Access Compliance Report

Public Rights-of-Way

Intersection ID: 5600	Main Street: N_TRYON_ST	Cross Street: J_M_KEYNES_DR	Location: W
ADA ID: C165C76CDFB8	Ramp Type: Perp	Initial Pass/Fail: Pass	Overall Compliance: No
		Severity Score: 20

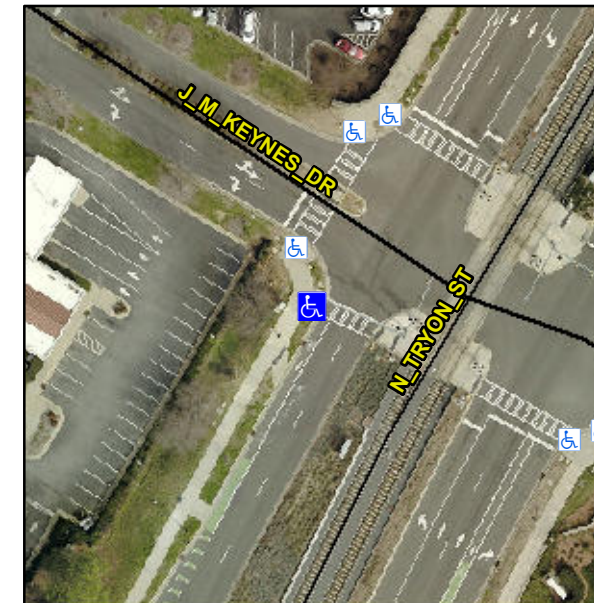
R302.7, R302.7.2, R304.5.4

Remove & Replace Gutter.
